# Sudden Valley Community Association Architectural Control Committee

## Agenda

Type of meeting: Request and Plan Review

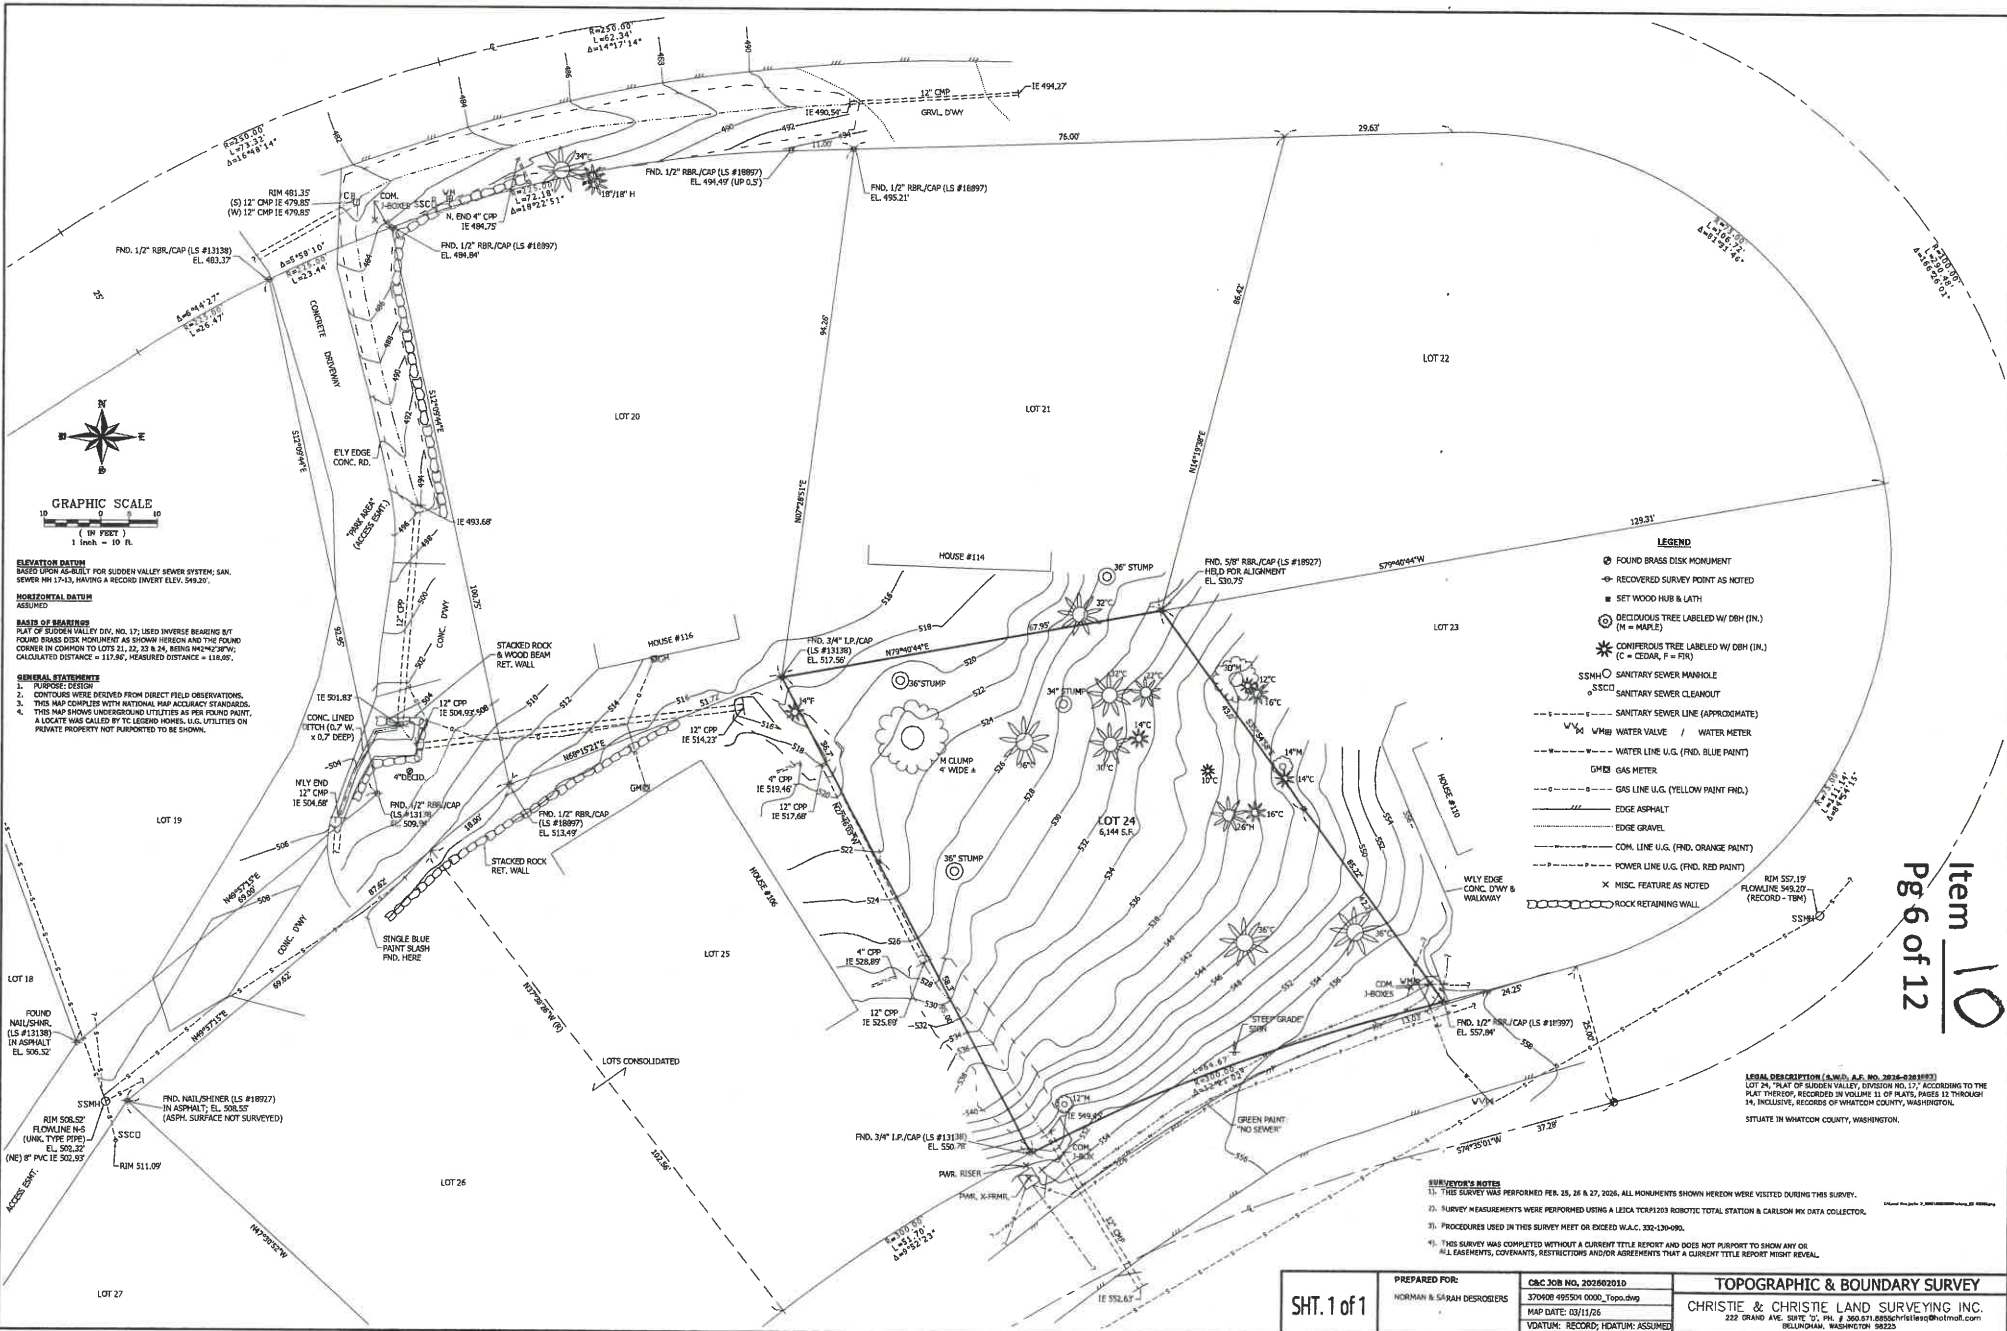
Driveway is very unique being raised off of the ground. I will still inspect for strip drain and curvatures at the road interface. Curvatures are not included in the site plan, and the driveway is above the 20' max width, there is no variance filled for the width.
